Global Companies LLC., 800 South Street, P.O. Box 9161, Waltham, MA 02454-9161 ph: 781-894-8800

March 2, 2021

RE: Supplemental Response to Request for Additional Information Related to  
the 2019 Climate Leadership and Community Protection Act  
Global Companies, Albany Terminal  
Air Title V Permit Application  
DEC #4-0101-00112/00029  
City of Albany, Albany County

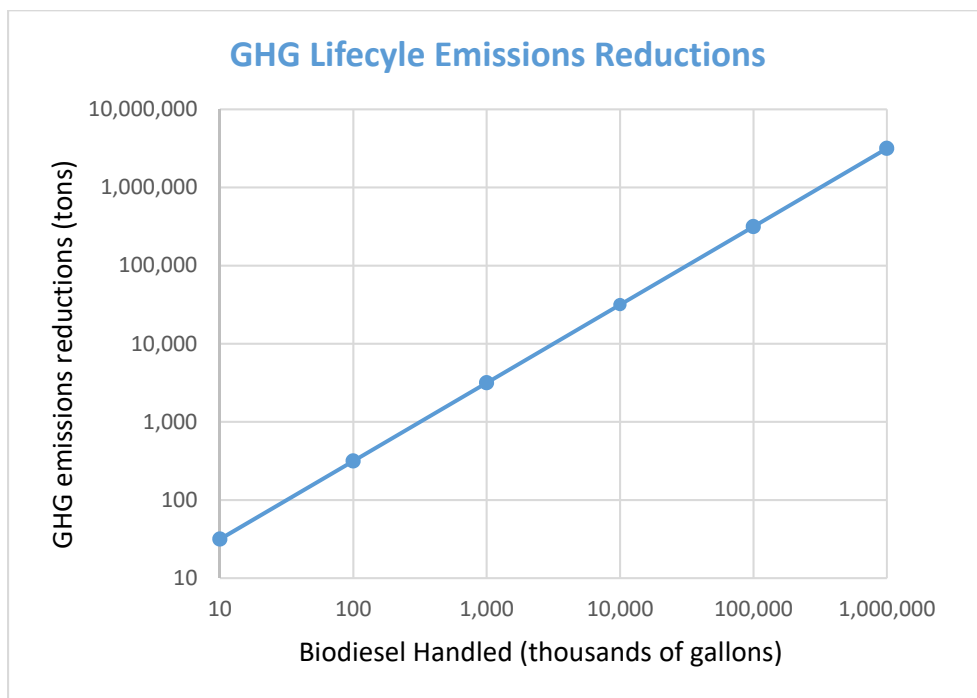
Global Companies LLC (Global or Applicant) is submitting this letter to supplement its previous submissions made in response to a pair of DEC requests for additional information (RFAIs) dated May 19, 2020 and September 11, 2020 seeking information concerning Global's application to renew and modify its existing Title V air permit for the Albany Terminal. Copies of those original submissions, excluding attachments, are included as Attachments A and B, respectively. Among other things, the RFAIs asked Global to assess the consistency of its proposed project with the goals of the 2019 Climate Leadership and Community Protection Act (CLCPA). Following submission of its December 3, 2020 response to the second RFAI, DEC asked Global to quantify the greenhouse gas (GHG) emissions associated with the extraction and transmission of project-related fuels imported into the state and combusted at the Albany Terminal. This submission responds to that request.

The graph below illustrates the relationship between GHG emissions from the boilers/heaters needed to manage biodiesel at the Terminal and the GHG benefits associated with biodiesel versus petroleum diesel. In the December 3, 2020 submission, a value was created by dividing the 27,784 tons of GHG emissions from the boilers/heaters by the maximum volume of biodiesel product that can be managed at the Terminal (about 300 million gallons). To address the emissions associated with extraction/transmission of the natural gas combusted in the boilers/heaters, a new value was created by dividing all emissions associated with the boilers (i.e., on-site combustion and upstream extraction/transmission) by 300 million gallons. These boiler/heater GHG emissions were then deducted from the lifecycle GHG emission reductions to obtain an estimate of the per gallon GHG benefits of biodiesel relative to petroleum diesel taking the new boiler/heater emissions estimate into account. Again, the results were plotted for different levels of biodiesel product.

Updated calculations are included as Attachment D. The information provided clearly shows that the Project will have a significant climate change benefit even when upstream emissions associated with extraction/transmission are included since it will enable the Terminal to manage fuel with much lower lifecycle CO<sub>2e</sub> emissions. These benefits more than outweigh the additional direct and upstream emissions associated with the boilers/heaters needed to manage those fuels.

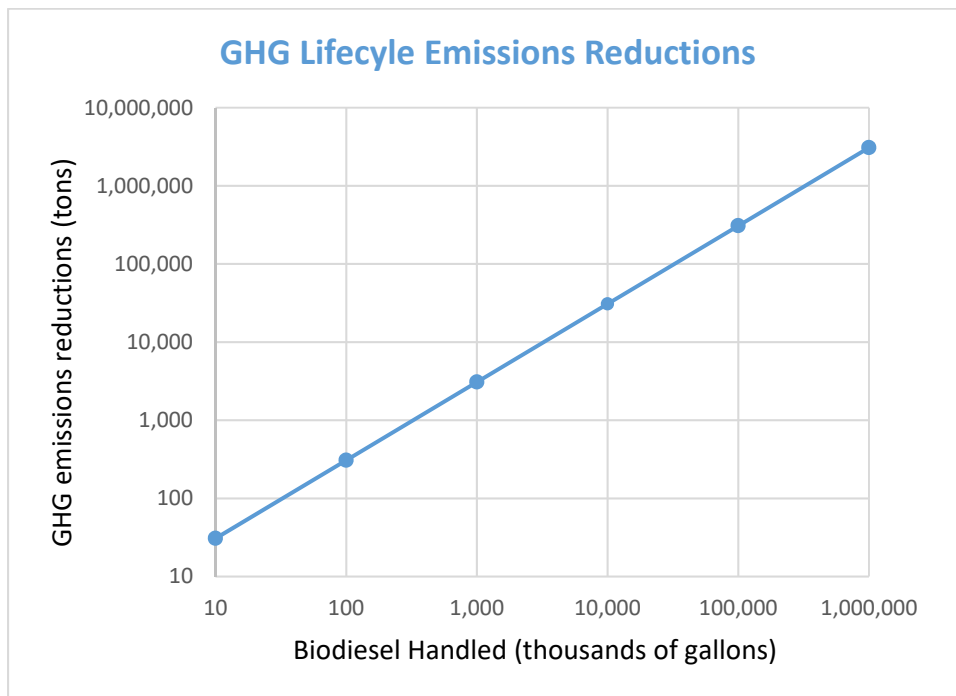
Per the Second RFAI, the CLCPA requires DEC—in considering Global’s application to significantly reduce product throughput and install boilers/heaters to manage biodiesel—to confirm whether its decision on the application will be inconsistent with or interfere with the attainment of the Act’s statewide GHG emission reduction limits. These limits—which were recently proposed by DEC—quantify the CLCPA’s goal of reducing GHG emissions 40% below 1990 levels by 2030. To answer this inquiry, Global compared the GHG benefits associated with swapping biodiesel for petroleum diesel (i.e., distillate) with the additional GHG emissions associated with the combustion of the natural gas used to fuel the boilers/heaters needed to manage the biodiesel at the Terminal. As previously noted, although Global currently handles only biodiesel that meets the 50% minimum threshold for biomass-based diesel, Global conducted its analysis using the 20% threshold for renewable fuels. In other words, Global calculated the GHG emission benefits associated with biodiesel assuming a 20% reduction from the lifecycle GHG emissions of distillate fuel. The emission factor for the lifecycle GHG emissions of distillate was

The graph below illustrates the relationship between GHG emissions from the boilers/heaters needed to manage biodiesel at the Terminal and the GHG benefits associated with biodiesel versus petroleum diesel. A value was created by dividing the 27,784 tons of GHG emissions from the boilers/heaters by the maximum volume of biodiesel product that can be managed at the Terminal (about 300 million gallons). The boiler/heater GHG emissions were then deducted from the lifecycle GHG emission reductions to obtain an estimate of the per gallon GHG benefits of biodiesel relative to petroleum diesel taking the boiler/heater emissions into account. The results were then plotted for different levels of biodiesel product.

The information provided clearly shows that the Project will have a significant climate change benefit since it will enable the Terminal to manage fuel with much lower lifecycle CO<sub>2</sub>e emissions and that these benefits more than outweigh the additional emissions associated with operating the boilers/heaters needed to manage those fuels.
